802.3bj 100GBASE-CR4 Comments D2

- **Additional material addressing comments against 802.3bj Draft 2.0**
- **Comment(s)**
 - **#187 (Mated test fixtures)**

Mated test fixture – CM–DM RL (SDC11/22)

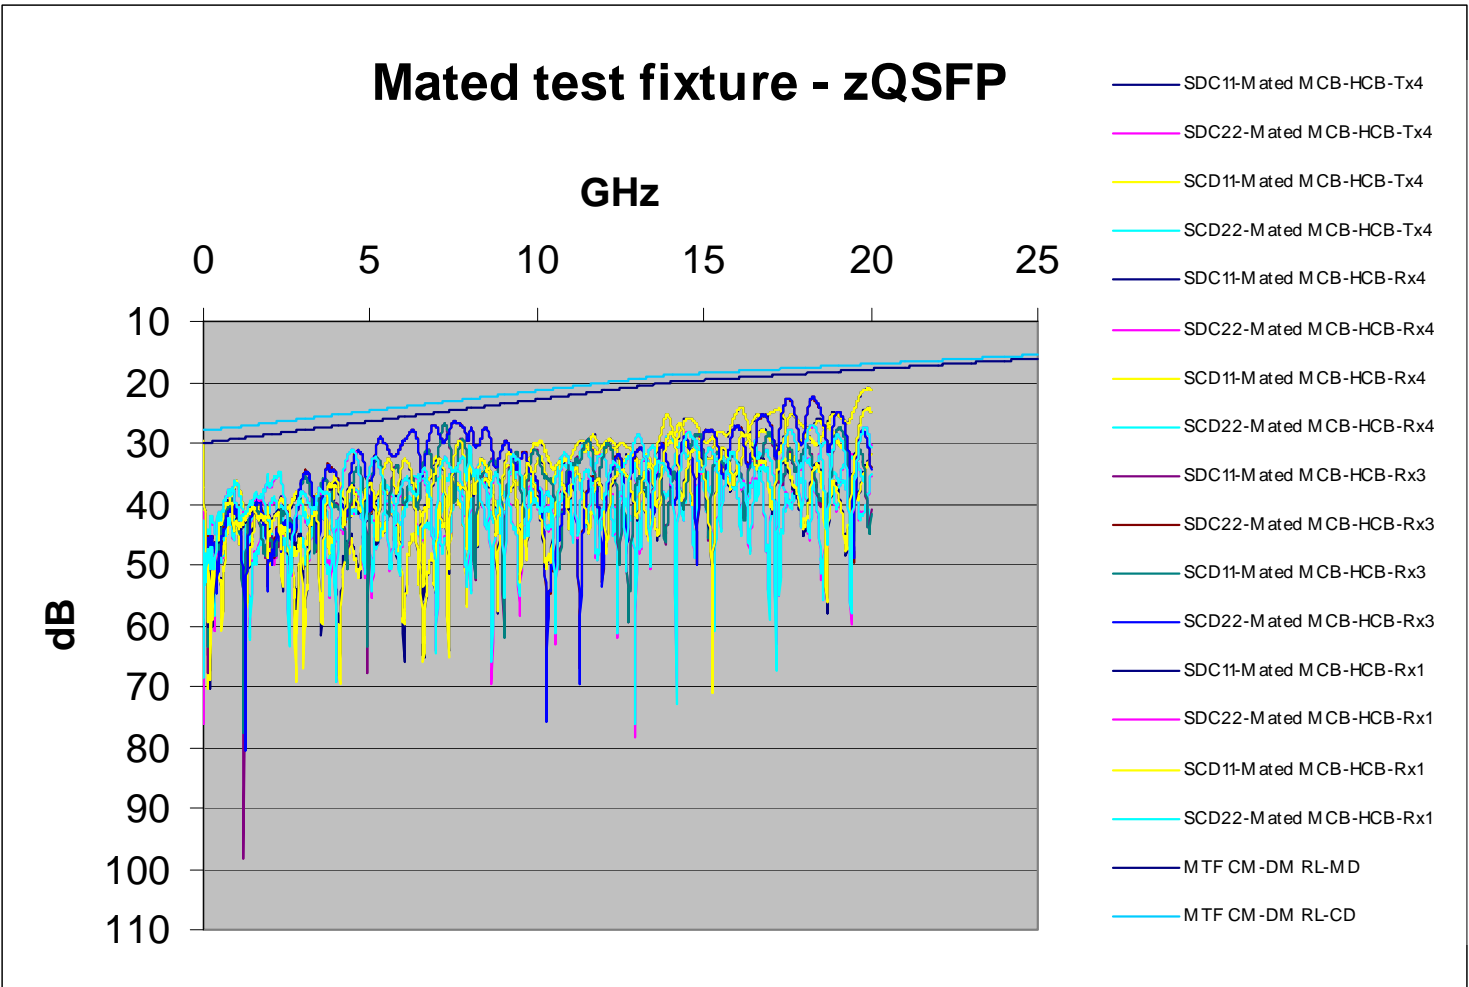
CI 92 SC 92.8.4.2 P 180 L 3 # 187

There is no specification for the mated compliance board common mode to differential return loss despite there being a specification for this for the receiver. With a realistic specification (that adopted by OIF VSR) at high frequencies the host product specification for the common mode to differential conversion is too close to that of the mated compliance boards making the specification almost impossible to meet. I will bring a presentation showing the effect to the Victoria meeting.

Add a specification for the mated compliance board common mode to differential return loss. Specification to be minimum $30-5/7^*f$ dB for $0.01 < f < 14$ GHz and $25-5/14^*f$ dB for $14 < f < 25$ GHz. Change the product specification in equation 92-8 above 12.89GHz from 12dB flat to $-18 + 6/25.78^*f$ which matches the specification OIF adopted for VSR at their last meeting.

PROPOSED ACCEPT IN PRINCIPLE. For committee discussion review with Dudek_3bj_01_0513.pdf

Minimum Mike Dudek –C#187

30-5/7*f dB **0.01<f<14 GHz**
25-5/14*f dB **14<f<25 GHz.**

Proposed change –C#187

28-0.658*f dB **0.01<f<14 GHz**
23-0.3*f dB **14<f<25 GHz.**
